APPLICATION NO.	FILING DATE	FIRST NAMED INVENTOR	ATTORNEY DOCKET NO.	CONFIRMATION NO.
09/870,418	05/30/2001	Michael K. Blackwell	CKB-001.02	8017

Office Action Summary	Application No. 09/870,418	Applicant(s) BLACKWELL ET AL.	
	Examiner Sean P. Shechtman	Art Unit 2125

In re Application of:)	
Blackwell et al.)	
Application No:)	Art Unit: 2125
09/870,418)	
Filed: May 30, 2001)	Confirmation No.: 8017
For: A METHOD AND APPARATUS)	Examiner: Sean P. Shechtman
FOR AUTHORIZING AND PLAYING)	
BACK LIGHTING SEQUENCES)

FIG. 1

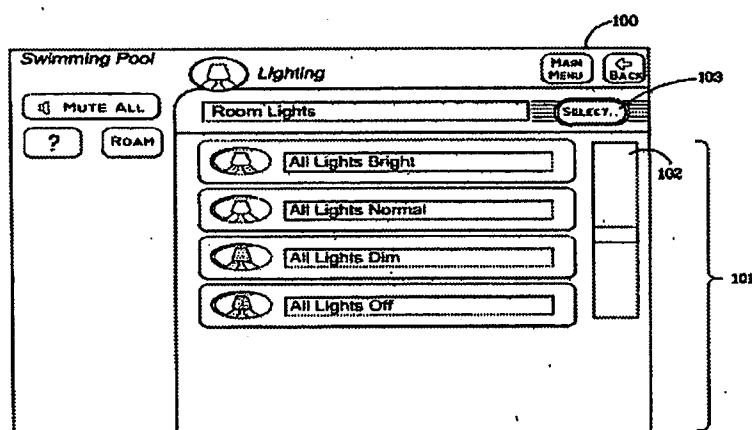
Referring to claims 68 and 84, Pyle teaches a system for preparing and playing back a light sequence, comprising an authoring interface displaying information representative of a plurality of lighting effects (bright and dim); a sequence authoring module to permit a user to select a lighting effect (bright or dim or intensity), a lighting unit to execute the lighting effect (room lights), a start time for the lighting effect, and a stop time for the lighting effect (Col. 5, lines 14-45); and a playback device, coupled to the lighting unit, to playback the light sequence (Col. 9, lines 34-64, especially lines 61-64).

Examiner respectfully notes that the instant specification teaches the term “light sequence” does not require sequential displays. In fact, the term “light sequence” only requires a controlled display with one light. The examiner respectfully submits that the lighting sequence is not required to be functionally related to or used with the authoring interface or sequence authoring interface.

Referring to claim 69, Pyle teaches the system of claim 68, further comprising a lighting set-up module to receive information representative of an arrangement of a plurality of lighting units, and a set-up interface to visually display the arrangement of the plurality of lighting units (See figure above).

Referring to claim 31, Pyle teaches the computer readable medium of claim 30, wherein the lighting program is encoded in a data format having an entry in the lighting program corresponding to every one of the plurality of states for the plurality of lights (See above figure).
